212 Miller, 7 October 2021

Design Review Board

Response to Planning Staff Review comments emailed to petitioner 10/7/2021 responding to questions to staff dated 9/28 & 9/29/21 from petitioner.

Schematic Design sketch of proposed Miller Avenue front bay window element.

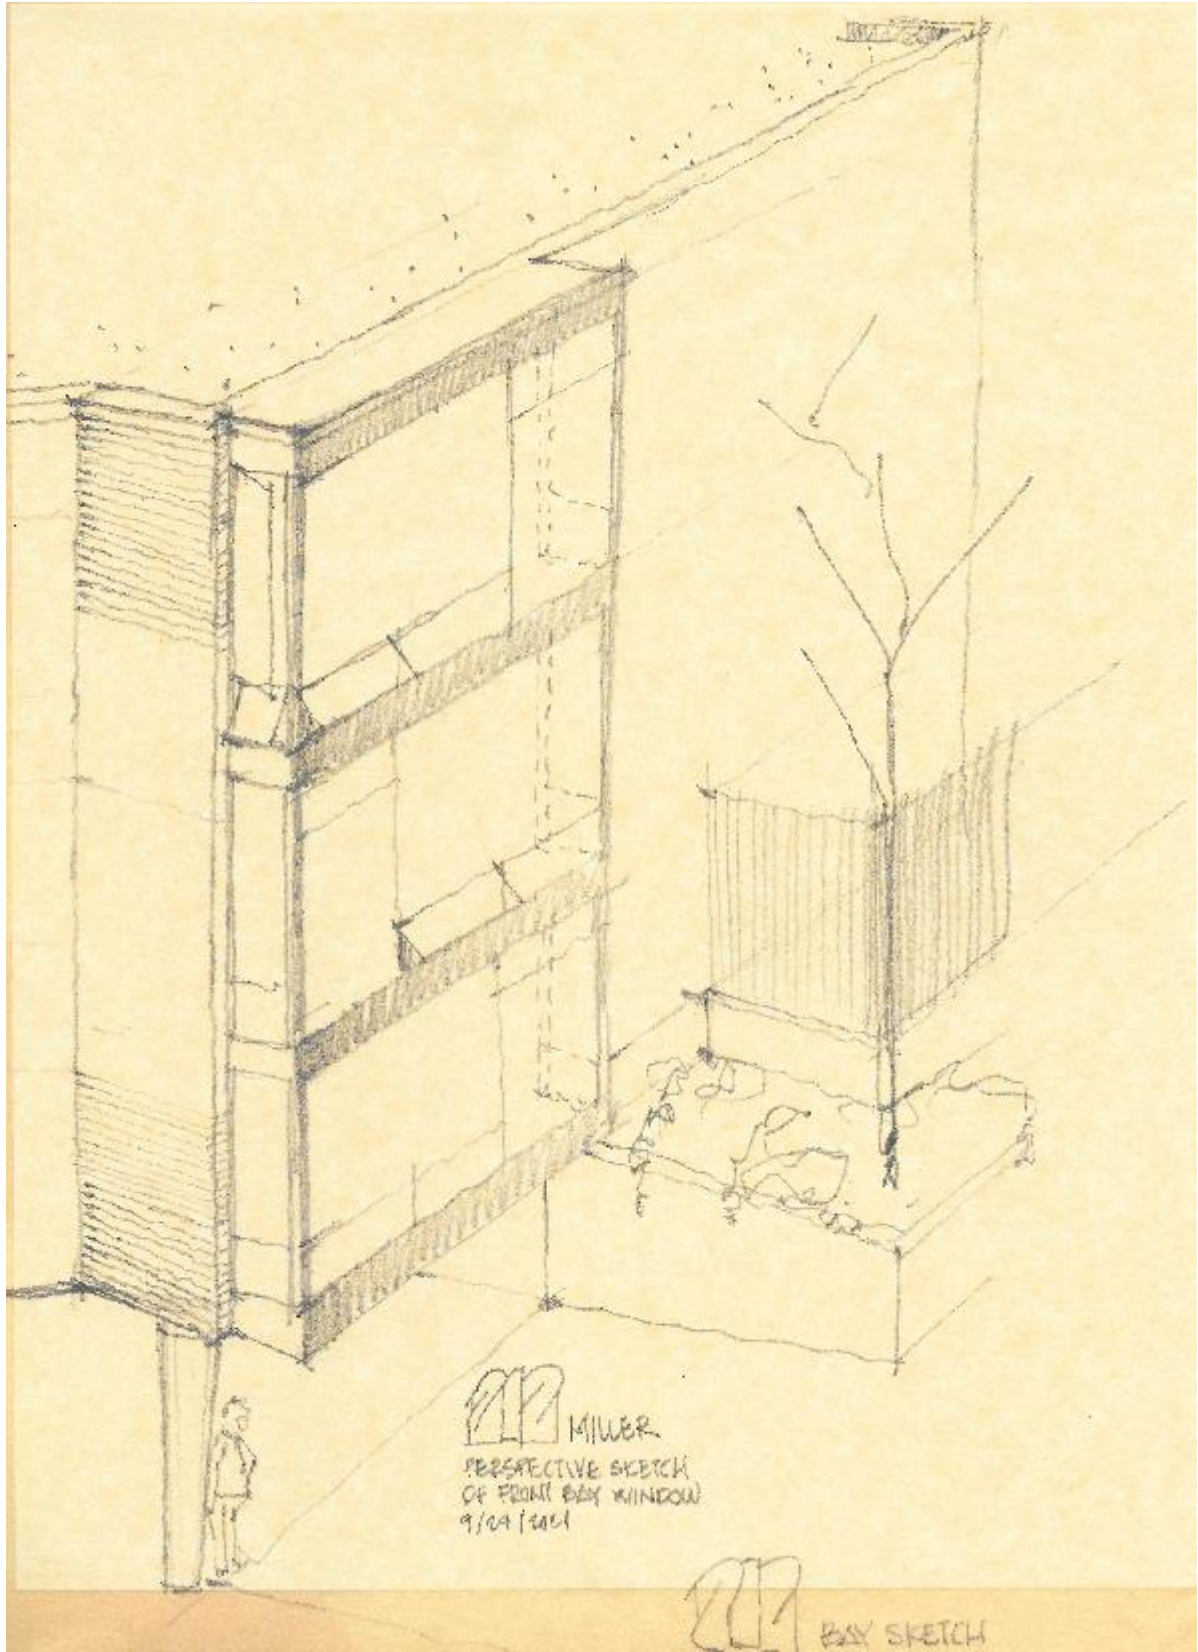
The south face of the building includes a cantilevered portion with a glass wall. Staff does not consider floor to ceiling features such as this to be a bay window (bay windows are allowed to protrude into a setback up to 2 feet). Therefore, if it protrudes into the 15 foot front setback (minimum front setback), it would be inconsistent with City code.

Staff: I haven't discussed with Mr. Kahan to date, however, I think the interpretation could be based on the projection representing approximately 1/3 of the entire south façade being more substantial than an architectural feature. It appears by the section and the floor plans provided that the building is designed with this as permanent floor area as well, rather than an added architectural feature akin to a balcony, eave, or other projection on the exterior wall of a building.

There is no definition in the UDC for bay window. The “glass wall” noted (see attached schematic design sketch) consists of window units infilling the front and two sides forming the bay window.

Bay windows are addressed in the UDC and allowed to project 2 feet into any setback, so this is not an inconsistent element as the code speaks to its allowance directly.

Note staff is calling this an interpretation and has not given the requested concise reason. The actual area devoted to the bay is c.¼ of the proposed south facade and c.1/10 of the allowable facade area allowed in the D2 district for this property. As noted above, bay window solutions also include habitable floor area to the interior of the space in which the bay resides. (See attached a few examples of which many dozens were found)

In the UDC, under 5.18.B. 3. *Certain architectural features, such as cornices, eaves, gutters, bay windows, and chimneys may project up to two feet into any Setback Areas.*

There is no other limitation set on this element in the UDC so, written definitions, historical precedent context, along with existing built examples in Ann Arbor and around the world should reinforce what an acceptable bay window would be.
